### Federal Aviation Administration

#### **Airworthiness Directives; Agusta S.p.A. (Type Certificate Currently Held by Agusta Westland S.p.A) (Agusta) Helicopters**

**ACTION:** Final rule.

**2013-16-21 AGUSTA S.p.A. (Agusta):**  
Amendment 39-17559; Docket No. FAA-2013-0146; Directorate Identifier 2012-SW-060-AD.

Figure 1 to Paragraph (f)(1), T/R Blade, P/N 109-8132-01-111

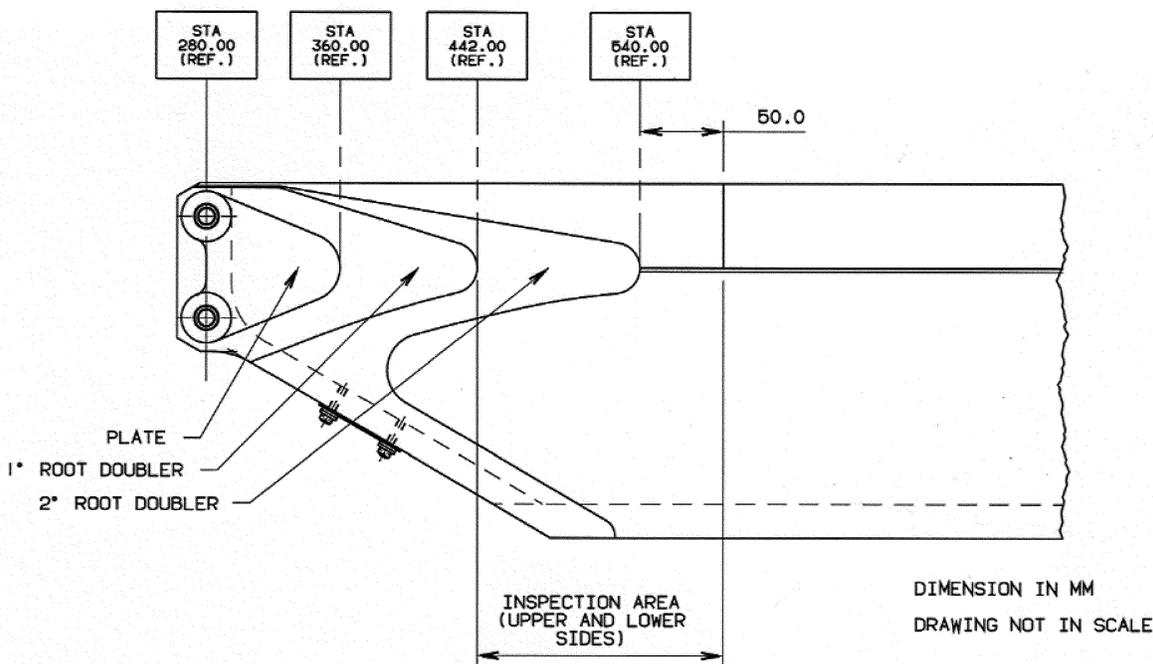
(1) Before each start of the helicopter engines, visually check both sides of each T/R blade for a crack in the inspection area depicted in Figure 1 to paragraph (f)(1) of this AD. This action may be performed by the owner/operator (pilot) holding at least a private pilot certificate, and must be entered into the aircraft records showing compliance with this AD in accordance with 14 CFR 43.9 (a)(1)-(4) and 14 CFR 91.417(a)(2)(v). The record must be maintained as required by 14 CFR 91.417, 121.380, or 135.439.
